Re: Response to ORCA Comments
Re: Natural Heritage Evaluation (NHE) and Previous Two (2) Responses
Proposed Turner Street Extension Residential Development (Veltri)
Part Lot 11, Concession 5 (Cavan)
Township of Cavan Monaghan, County of Peterborough
ORE File No. 15-2013

**Natural Heritage Evaluation (NHE)
Proposed Turner Street Extension
Residential Development (Veltri)**
Part Lot 11, Concession 5 (Cavan)
Township of Cavan Monaghan
County of Peterborough

Vegetation Plan

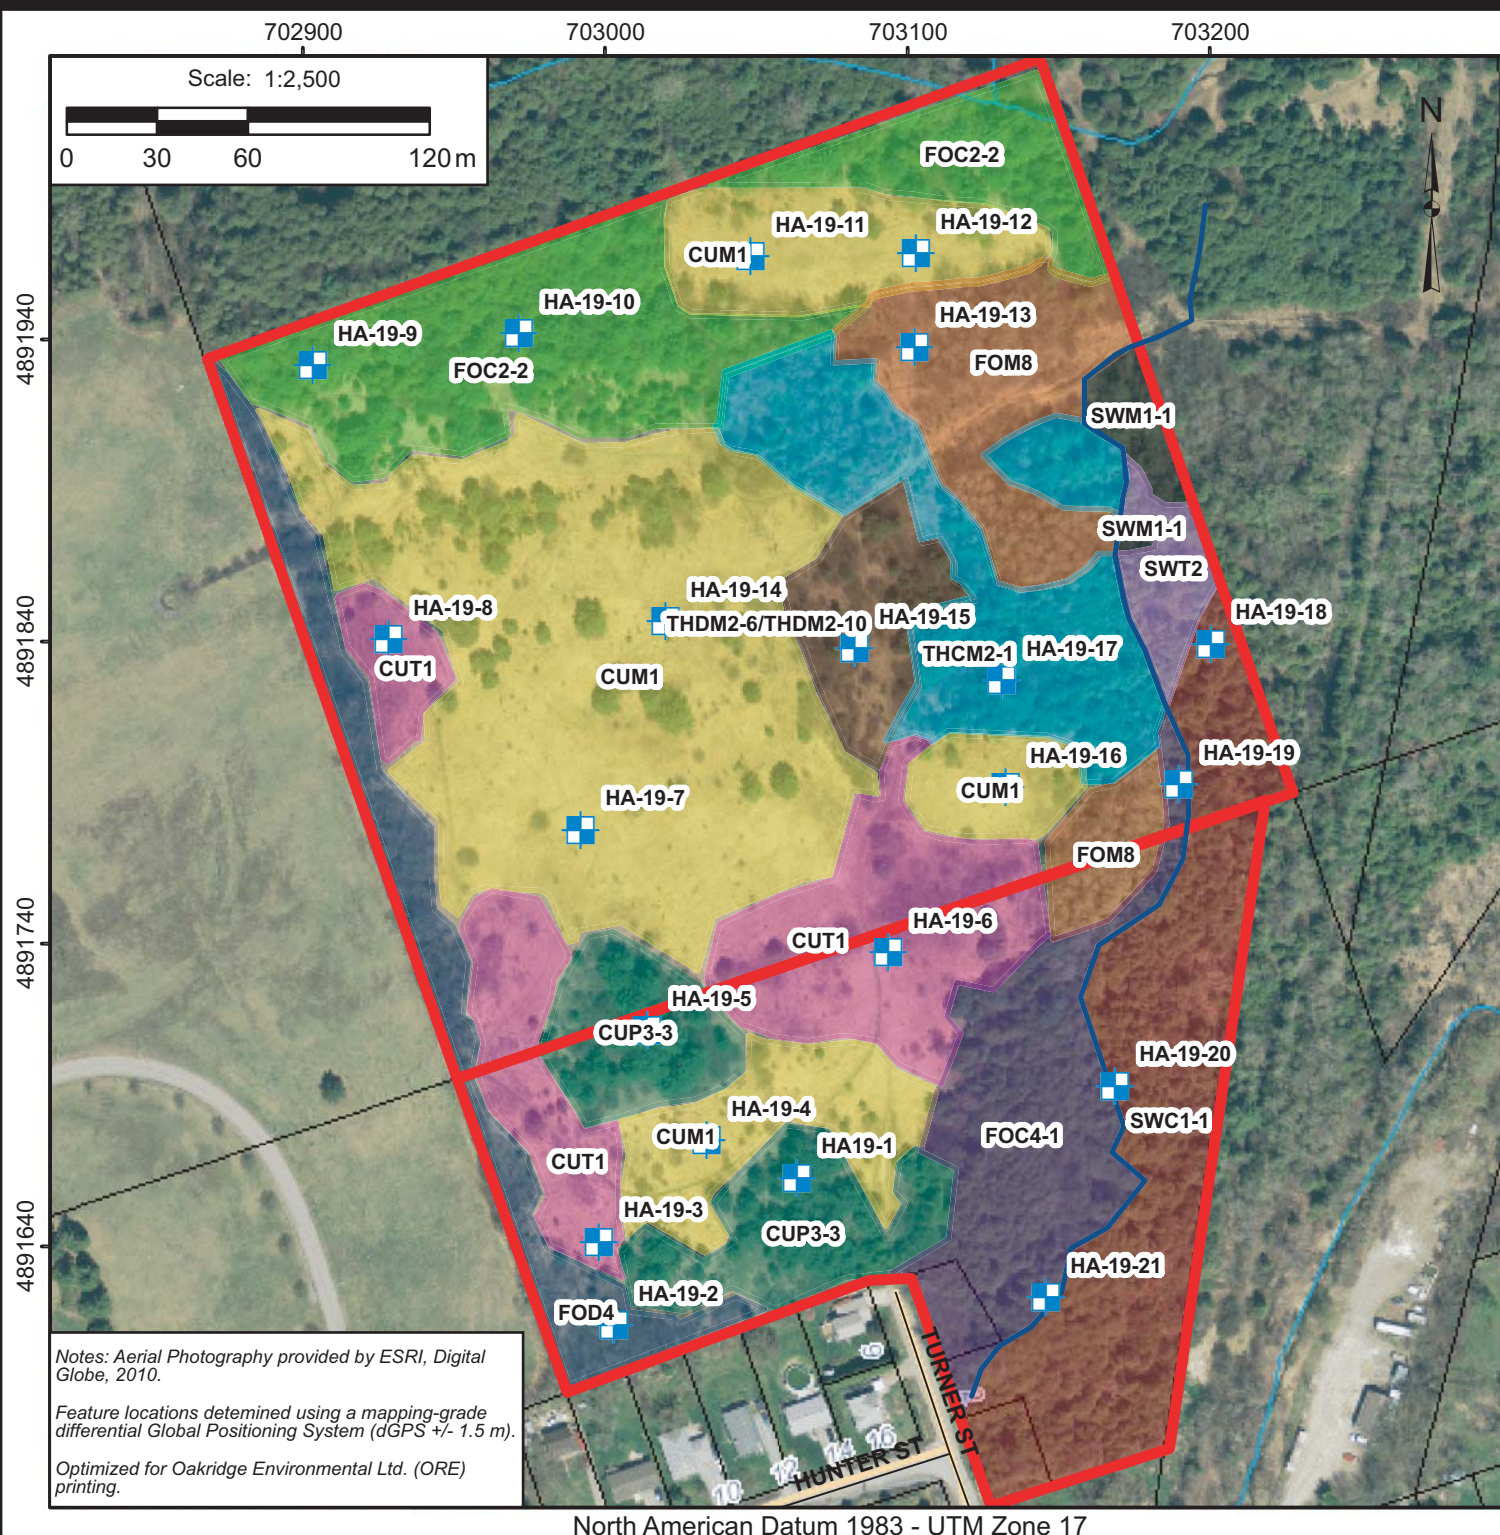
“g) Otonabee Conservation policies 7.0(1), 7.1(1, 2, & 6) and 7.2(2, 4, 8, 10, & 16) direct development outside of wetlands and /or within 30-metres of the wetland boundary.

- ORE confirms wetland communities SWC1-1, SWT2, and SWM1-1 maintain the same boundary as the 'ephemeral discharge' area. Updated plans will rename 'ephemeral discharge' area to 'wetland' in support of the Otonabee Conservation permit.*

- The plans have been updated to refer to the ephemeral discharge areas as “wetland” in the SWC1-1, SWT2, and SWM1-1 communities on Figure 5r (Vegetation). ORCA agrees with the location of the ORE-defined wetland boundary provided on Figure 6r and within the Draft. The 30 m VPA has been applied to the ORE wetland boundaries which is consistent with the OP and PPS requirements to protect the on-site wetland features.
- Fill Placement and Grading limits all occur 30 m or greater from the wetland boundary, therefore, are consistent with ORCA’s regulatory policies 7.1(1 & 2) and 7.2(2, 4, & 16) and also the NHE recommendations in the revised Draft Plan/Conceptual Servicing Plan.
- It was determined that a separate EIS would be completed to review the best

Constraints Plan

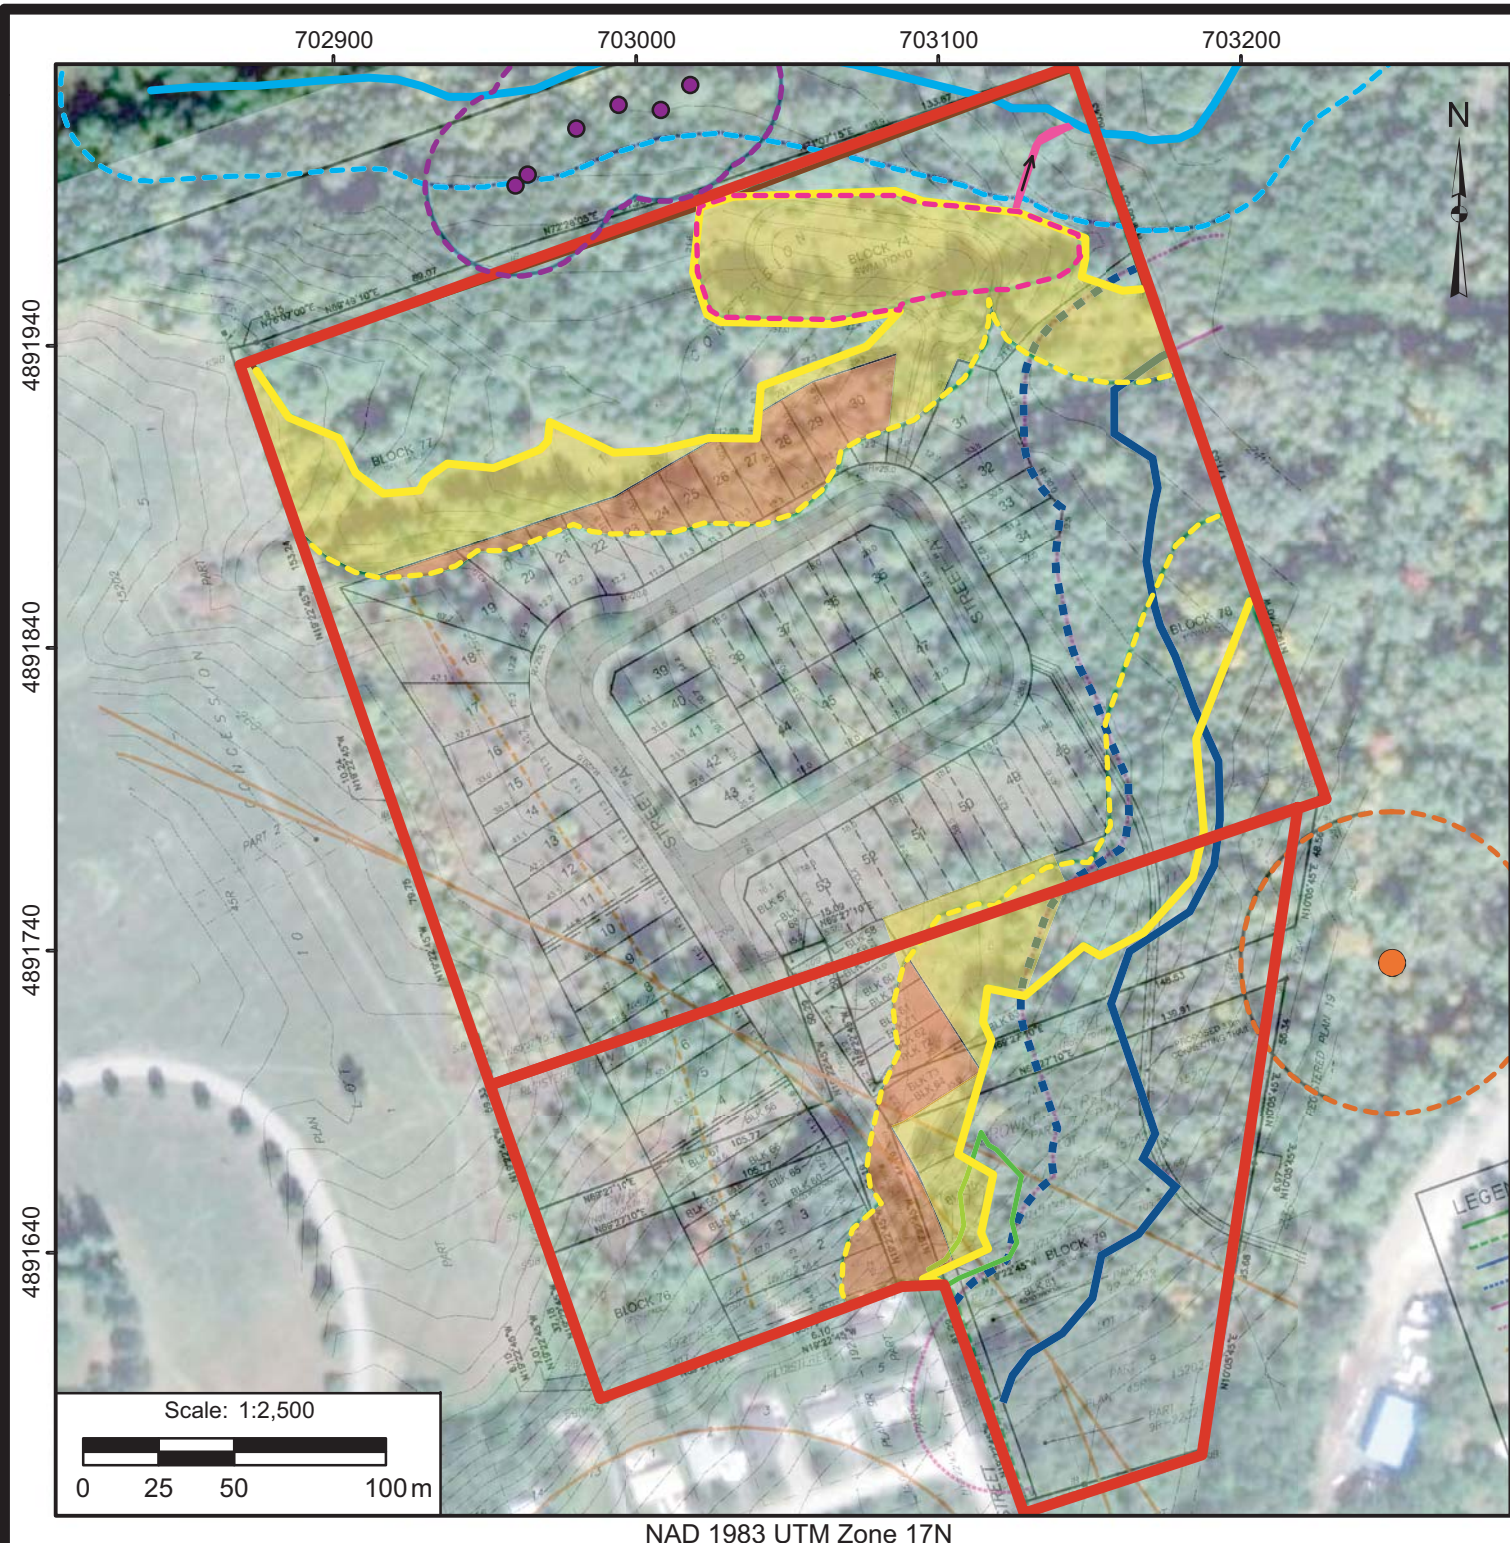
"d) Would grading into the 30-m wetland buffer still be necessary if lot fabric was reconfigured? To satisfy relevant policies, technical staff recommend using Lots 54 and 55, and associated blocks, as a planting area to compensate wetland / woodland loss from the proposed upgrades to existing uses (e.g., road widening and /or recreational trails)."

"2 a) To demonstrate consistency with the intent of PPS policy 2.1.2, 2.1.6 and 2.2.1, as well as ORE comments on pages 7, 11 and 18, to protect cold-water fish habitat and seeps within the valley (Figure B), development and site alteration should avoid encroachment into these hydrologic features and the 30-metre buffer / VPZ (orange circle).."

Insofar as those areas of the Significant Woodland’s 30 m VPZ that will be encroached upon, these will be mitigated elsewhere via intensive plantings/naturalization on-site. The proposed planting areas are identified on Figure 6r. The planting of these edge areas between the proposed development and core woodlands will improve connectivity between woodland tracts and will improve the quality of runoff being directed to the wetland/waterways (e.g., the areas east of proposed lots 59, 60, 61, 62 and 73).

- The Draft Plan and the engineering plans have been updated so that the lot fabric and associated proposed grading and servicing will be outside the wetland 30 m buffer. This should no longer be a concern.
- Figure 6r includes the Draft Plan (Appendix A) which demonstrates compliance with establishing a 30 m VPA off the Wetland boundary throughout the property.

- Lots 54 and 55 have been removed within the block that was proposed along the east side of the Turner Street Extension on the steep section of the hillside. A small SWM Pond is now proposed to occur in this area, however, it occurs entirely outside the 30 m VPZ of the wetland and outside of the boundary of the Significant Woodland. Once the pond is constructed in the small meadow opening towards the top-of-bank, it can become part of the planting area to compensate for similar encroachments into the Significant Woodland 30 m VPZ, as per ORCA's recommendation above. The small southerly SWMP area is identified on Figure 6r as a planting area.

- ORE staff and the proponent will determine the compensatory tree densities to be planted on-site in conjunction with the Township and ORCA as part of the compensation measures to mitigate the imposition of some development elements within the 30 m VPA/setback of the significant woodland, as identified on

Figure 6r demonstrates the development will maintain a 30 m or greater distance from all hydrologic features identified on-site, with the exception of the road access area extending Turner Street onto the subject lands. Encroachment into the 30 m VPA in this location is unavoidable. Any upgrades to Turner Street would be completed as per ORCA's regulation and the requirement of a specific study that attempts to limit impacts to the wetland/seeps and coldwater tributary in this location.

PRELIMINARY DRAFT PLAN
PART OF LOT 11, CONCESSION 5
Former Village of Millbrook, Township of Cavan
Now In The
TOWNSHIP OF CAVAN MONAGHAN
COUNTY OF PETERBOROUGH

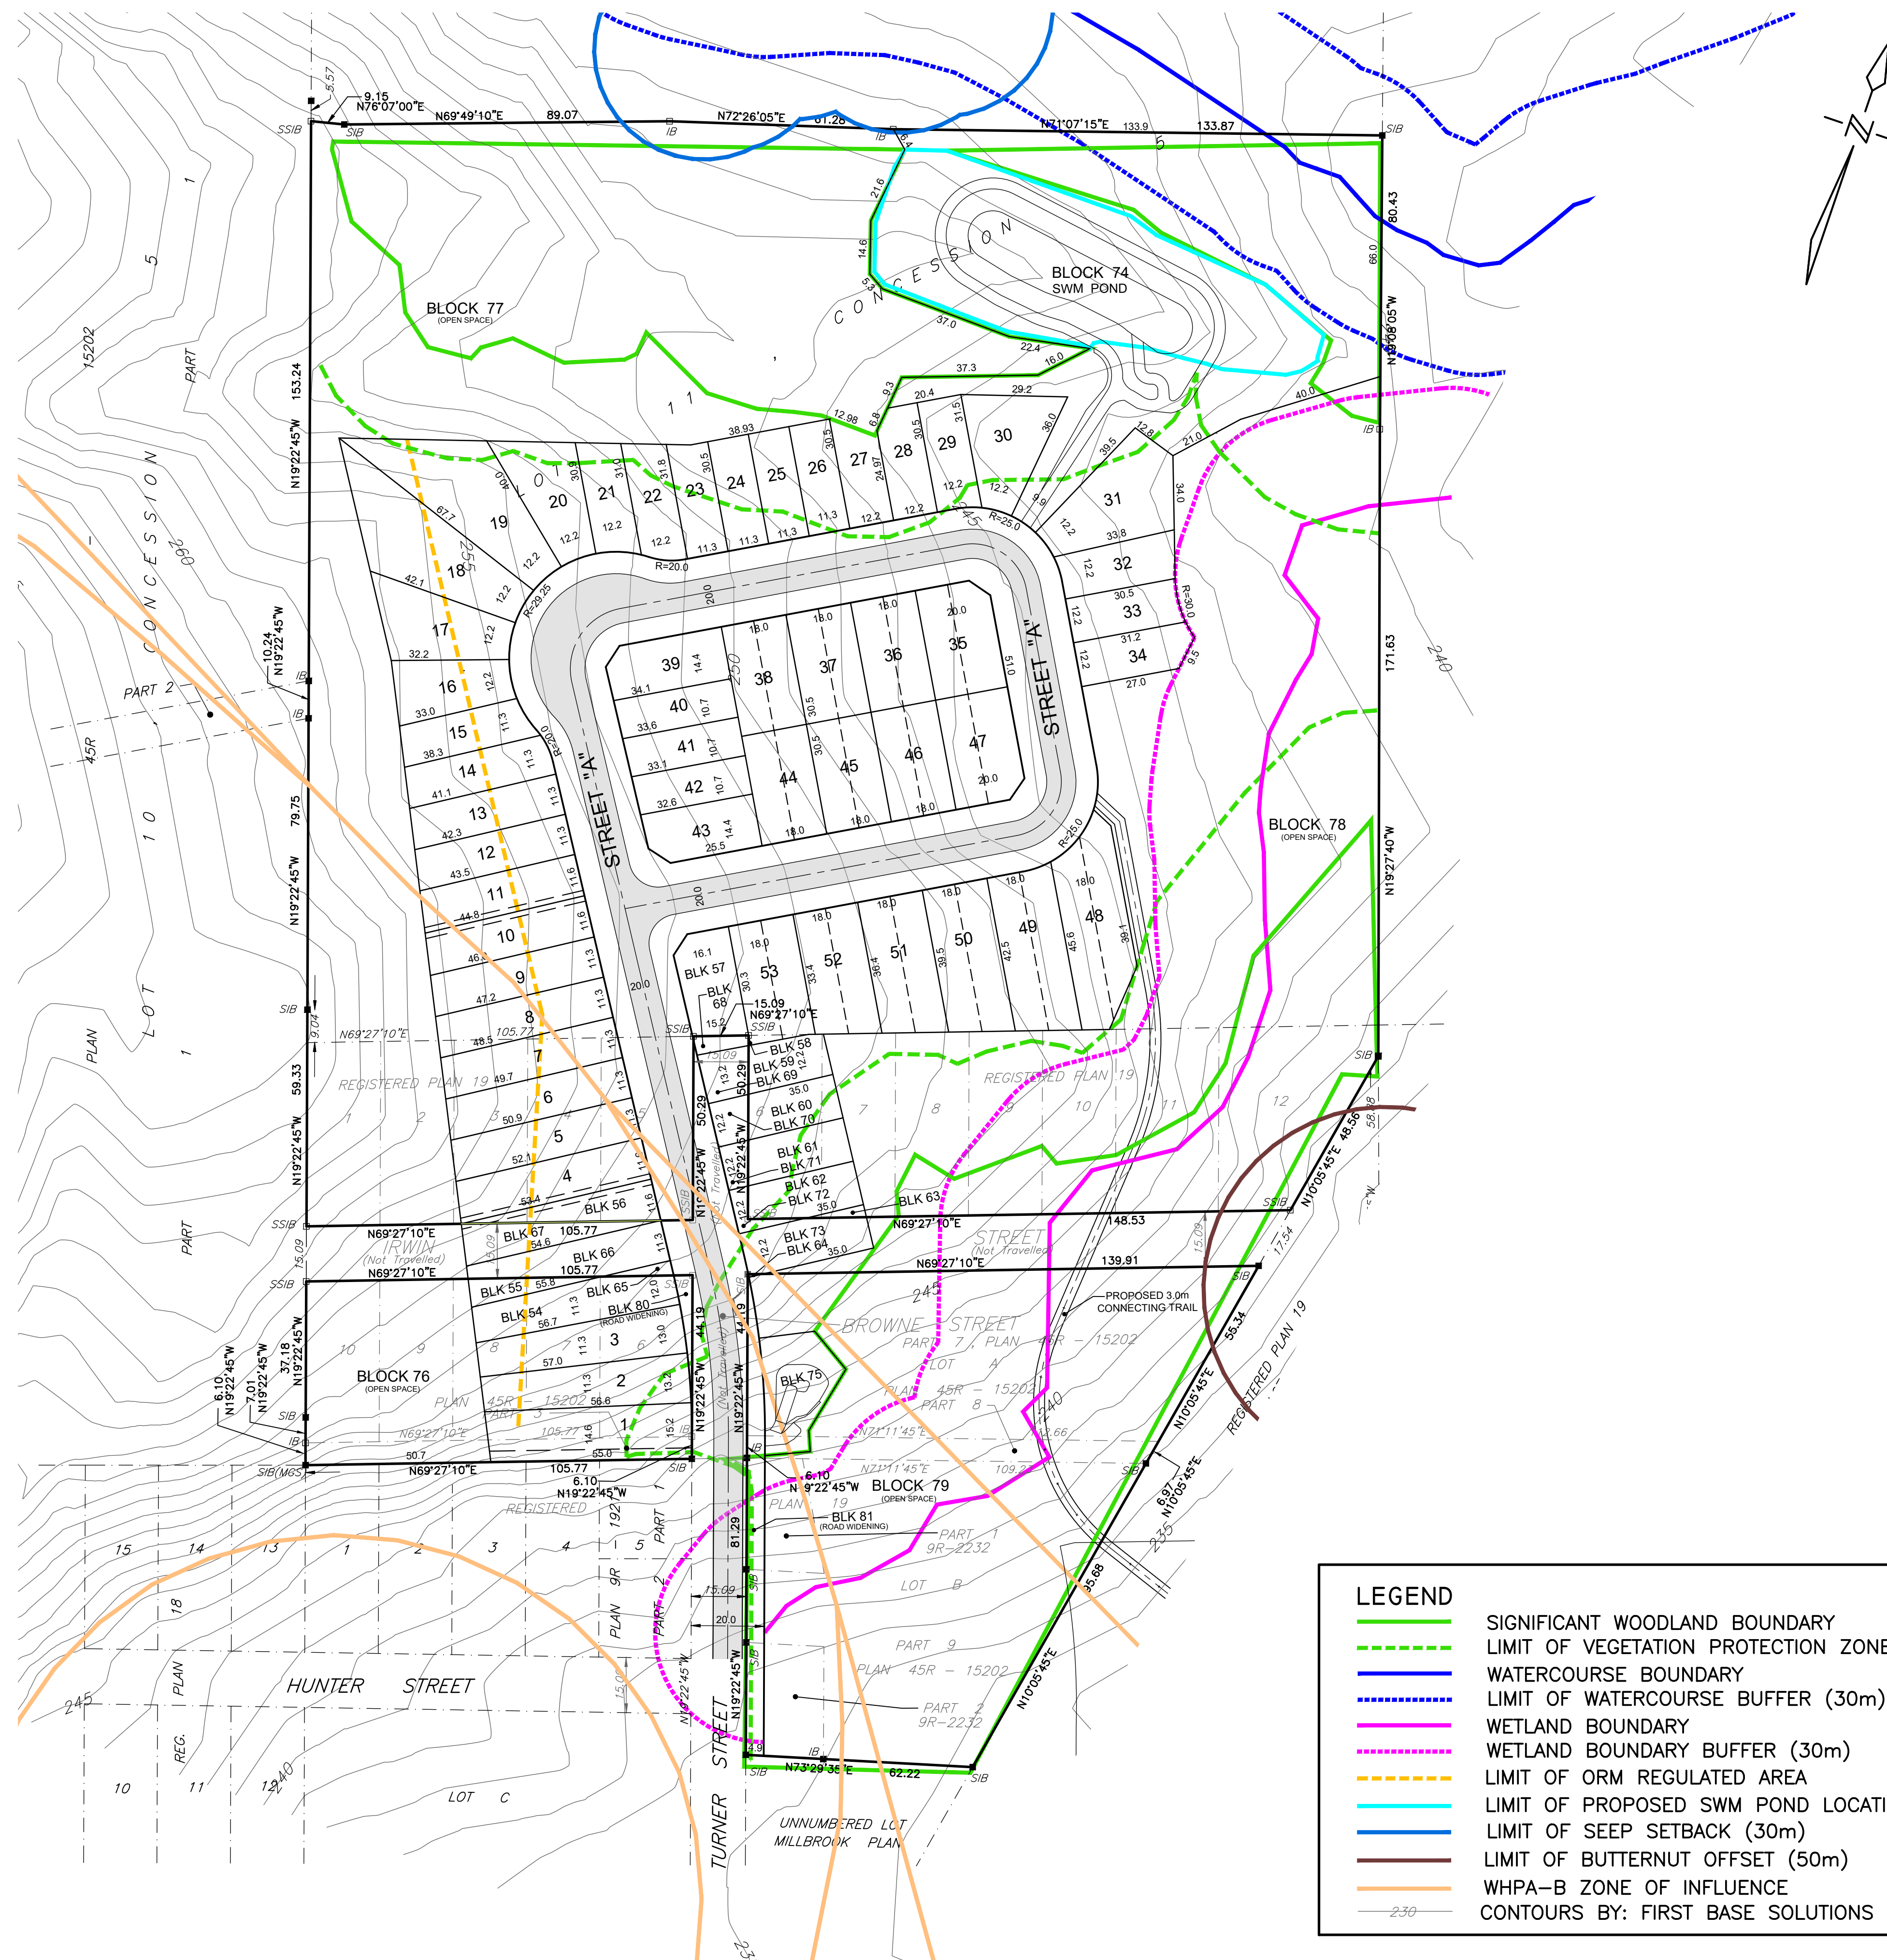
"b) According to ORE, "development will remain entirely outside of the 30 m VPA setback of all hydrological features" and "if the 30 m setback cannot be achieved / maintained from the wetland, or if the proponent would like to challenge the wetland boundary, a Wetland Evaluation must be completed to the MNR's satisfaction" (see ORE comments pages 9-15 & 18)."

- The revised Draft Plan (Appendix A) and Conceptual Servicing Plan (Appendix B) now complies with the 30 m VPA setback for all hydrological features. Therefore, it will not be necessary to challenge the wetland boundary or complete a Wetland Evaluation to the satisfaction of the MNDMNR.
